Planning Application Ref: BR/322/18/T

Location: Corner of Sudley Gardens, Bognor Regis, PO21 1HY

Description of works: Crown reduction of 2m and Crown lift of 5m to 1no. holm oak tree

Figure 2 Positions of final cuts

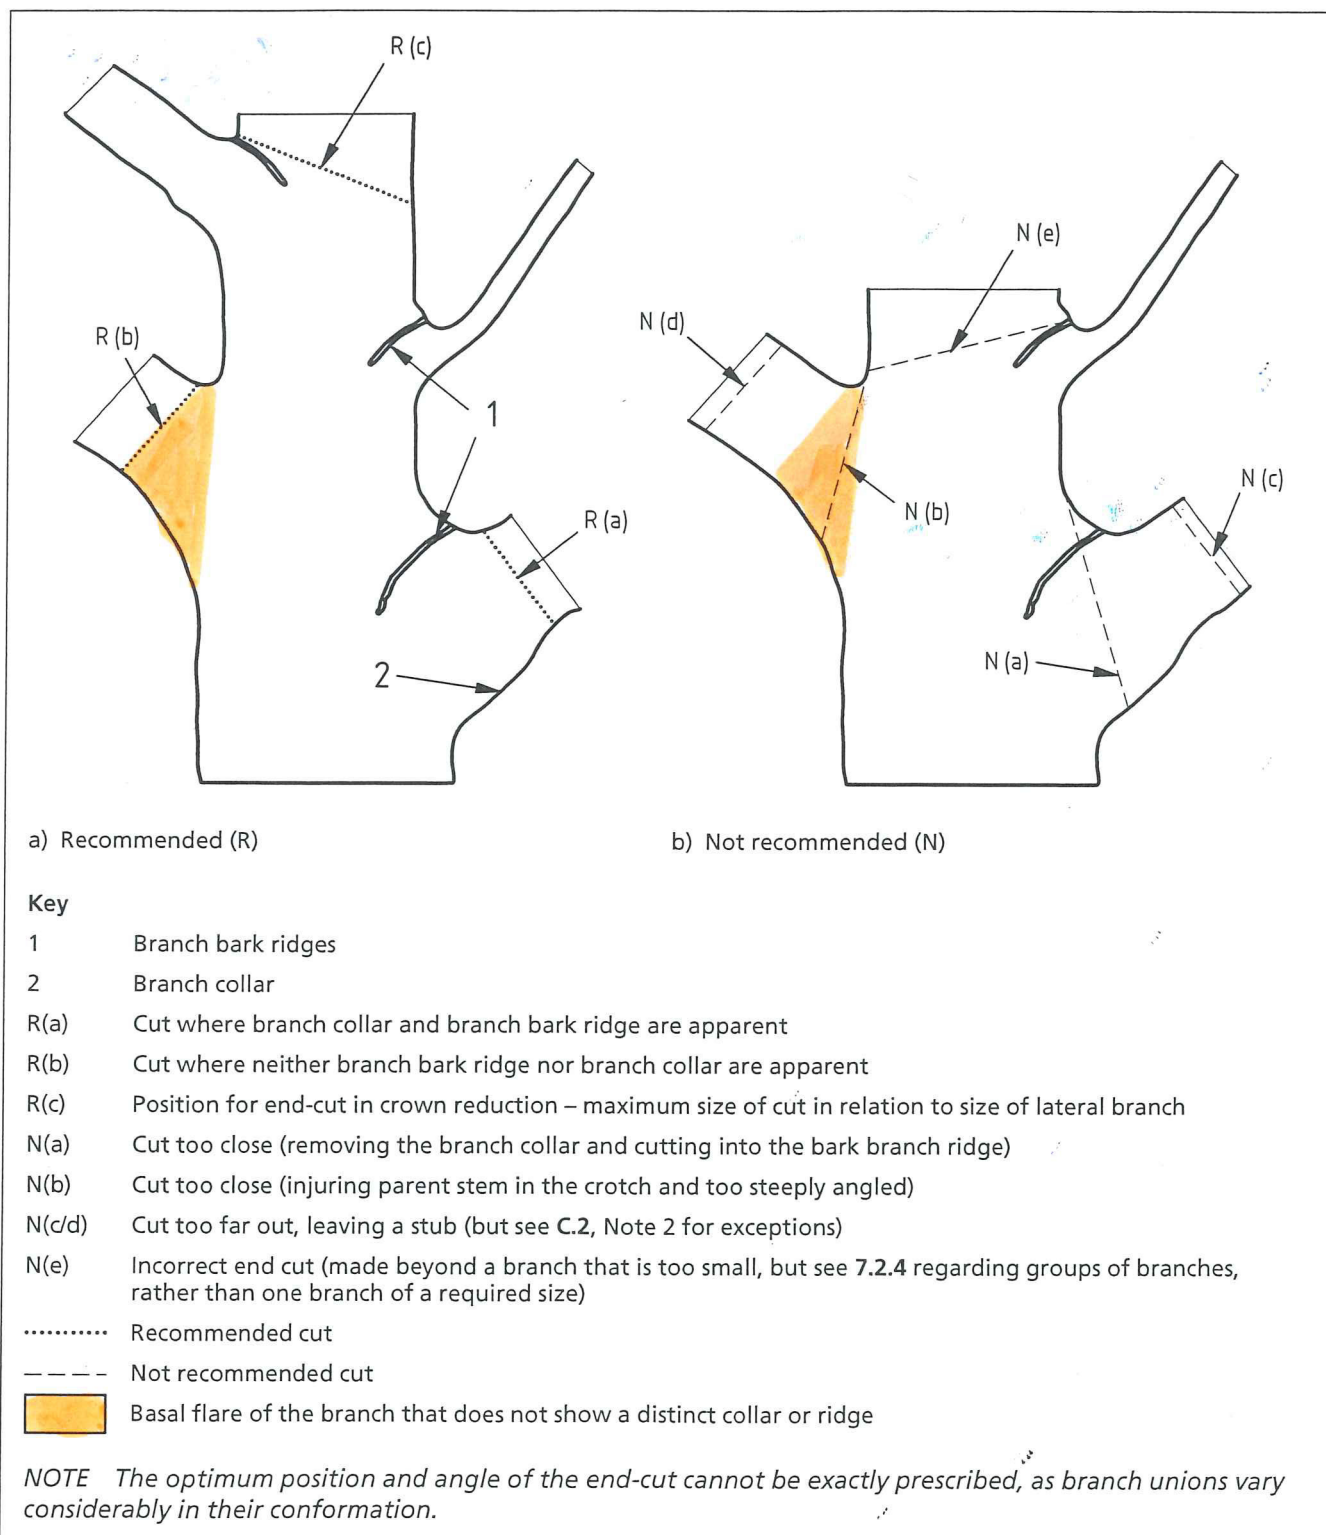
- Where whole branches are to be removed and final cuts made close to the trunk or branch union they are to be made as shown in Figure 2 of BS3998:2010
- Where branches are to be shortened back the final cuts are to be made at the correct angle shown in BS3998:2010 and adjacent to a live bud or lateral.
- The removal of crown material which has developed since the last operation must be done sympathetically and with respect to established 'knuckles' so as not to extend beyond the point of origin.
